**Sec. 4-115. - General exceptions and amendments applicable to all technical codes.**

**Sec. 4-120. - Specific Amendments to the 2021 International Building Code.**

Figure 307.4

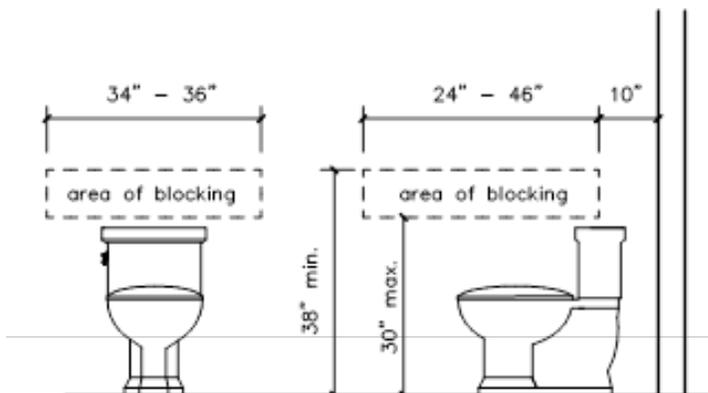
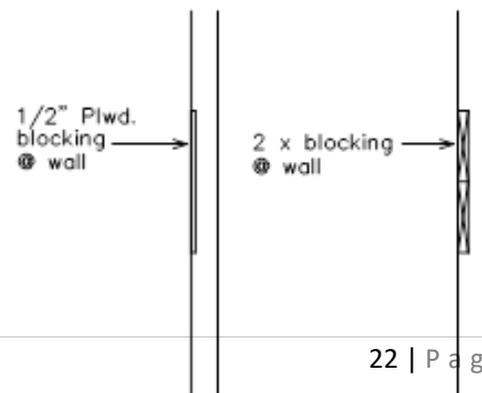
**R307.3 Blocking.** Required at one toilet at grade level. Blocking per Sec. R307.4 and Figure 307.4, shall be installed at rear wall and one wall adjacent to toilet at the lowest living level where a toilet is provided.

**R307.4 Blocking.** Blocking may be 1/2" plywood or equivalent or 2 x solid wood blocking flush with wall.

**Figure R602.6.1; delete the figure and insert the following figure:**

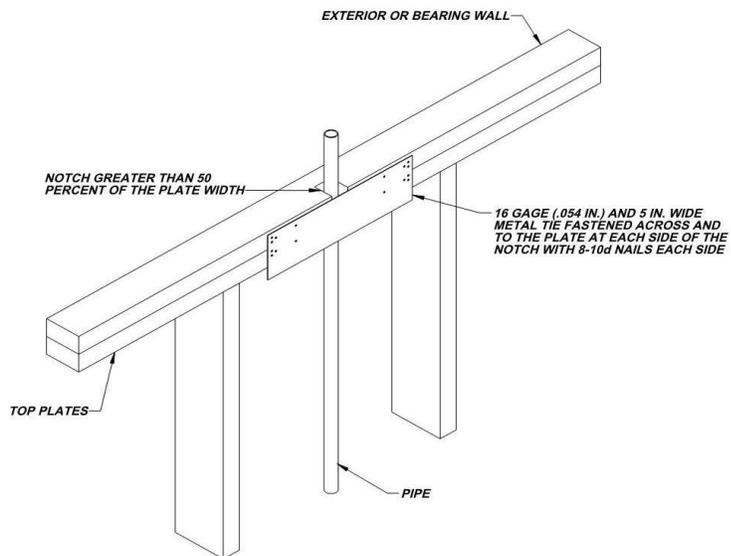
**R602.6.1 Drilling and notching of top plate.** When piping or ductwork is placed in or partly in an exterior wall or interior load-bearing wall, necessitating cutting, drilling or notching of the top plate by more than 50 percent of its width, a galvanized metal tie not less than 0.054 inch thick (1.37 mm) (16 Ga) and ~~1 ½ inches (38 mm)~~ 5 inches (127 mm) wide shall be fastened across and to the plate at each side of the opening with not less than eight 10d (0.148 inch diameter) having a minimum length of 1 ½ inches (38

mm) at each side or equivalent. Fasteners will be offset to prevent splitting of the top plate material. The metal tie must extend a minimum of 6 inches past the opening. See figure R602.6.1. {remainder unchanged}

**Section 503.4.1 Traffic Calming Devices.** shall be amended as follows:

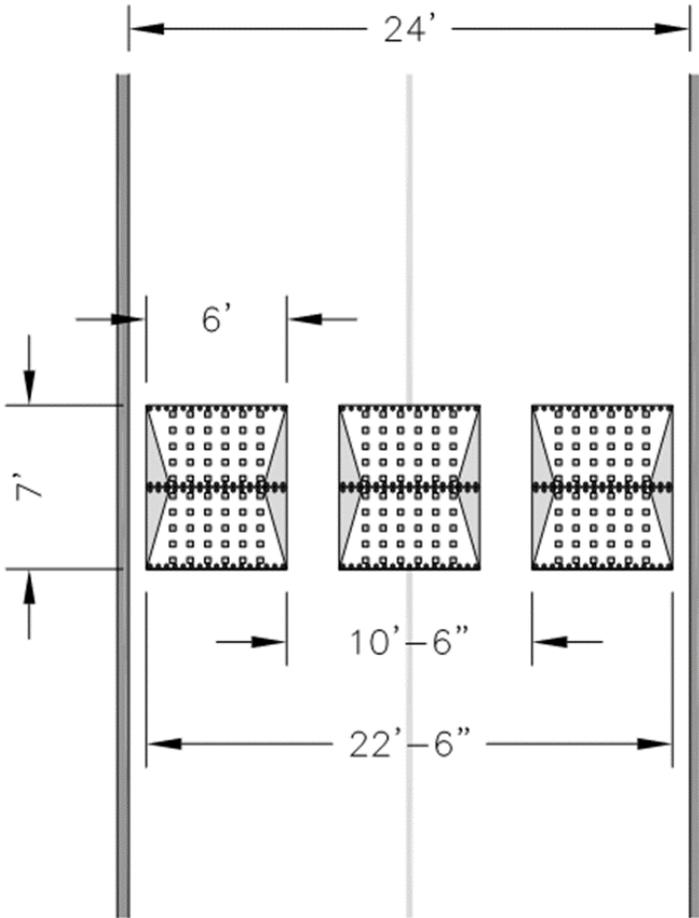
**Section 503.4.1 Speed Cushions** across fire apparatus access roads shall meet the design requirements specified in the Keller Unified Development Code as noted below:

1. Dimensions 3"x6'x7'
2. Entrance and Exit Gradient: 1:15
3. Side Gradient: 1:3
4. Material: Compression molded 100% recycled natural rubber and polyurethane.
5. Advance Notification: Some advance notification of the speed-reducing devices required.
6. Spacing: Minimum spacing of 200 feet between speed cushions.

<b>WATER CONSTRUCTION DETAILS</b> <b>RESIDENTIAL FIRE SPRINKLER SERVICE</b>	REVISION DATE: 8/2/2012
		SHEET: W-15

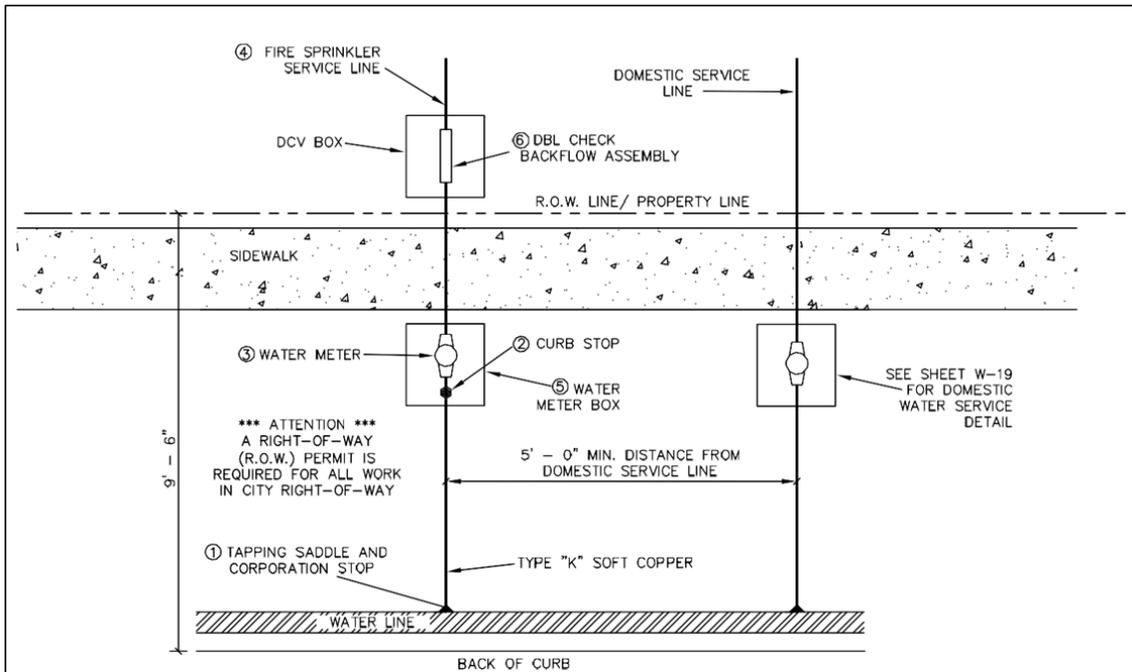
**Add Section 903.3.1.3.1 to read as follows:**

**903.3.1.3.1 Residential sprinklers.** Unless specifically allowed by this Code, residential sprinkler systems installed in accordance with NFPA 13D or NFPA 13R shall not be granted exemptions or reductions, commonly known as “trade-offs” permitted by other requirements of this Code. Additionally, residential sprinkler systems installed in accordance with NFPA 13R shall include attic protection. Water supply for residential fire sprinkler systems shall be provided by way of a separate tap and meter as detailed in the Keller Unified Development Code as noted below:

ADD: Figure: 25 TAC §265.186 (e) (6)

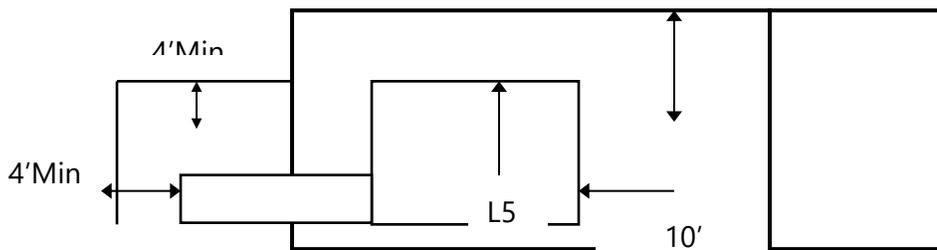
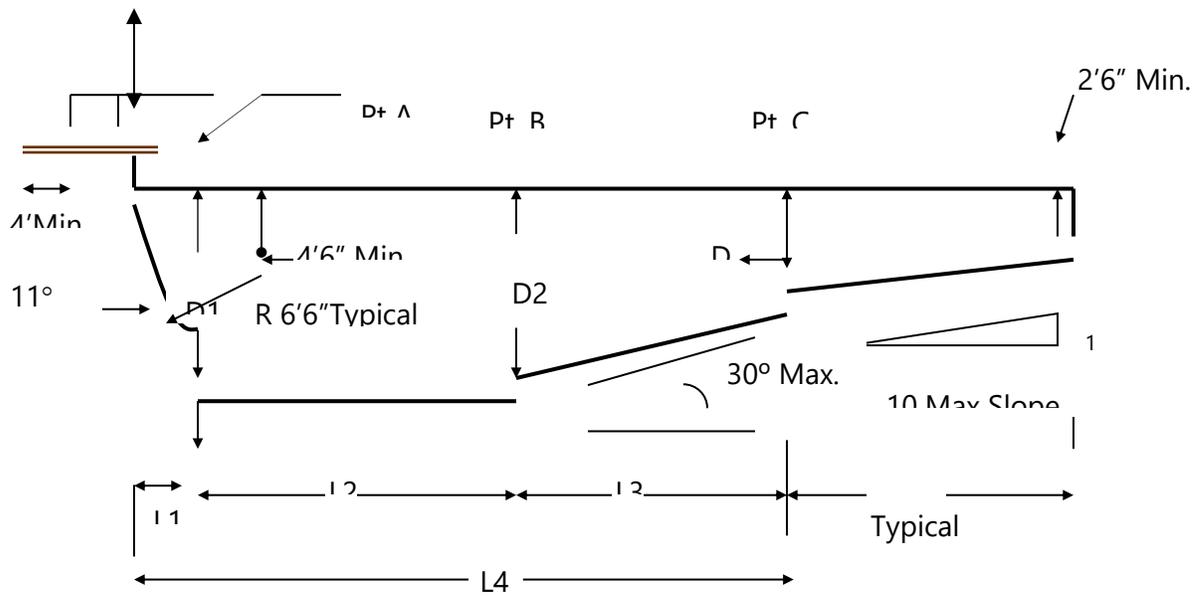
**Section 402.12; Change to read as follows:**

**402.12 Water envelopes.** The minimum diving water envelopes shall be in accordance with Table 402.12 Texas department of State Health services, Administrative Code Title 25, Chapter 265, Section 186 (e) and Figure: 25 TAC 256.186 (e) (6). (Delete Table 402.12 and Figure 402.12)
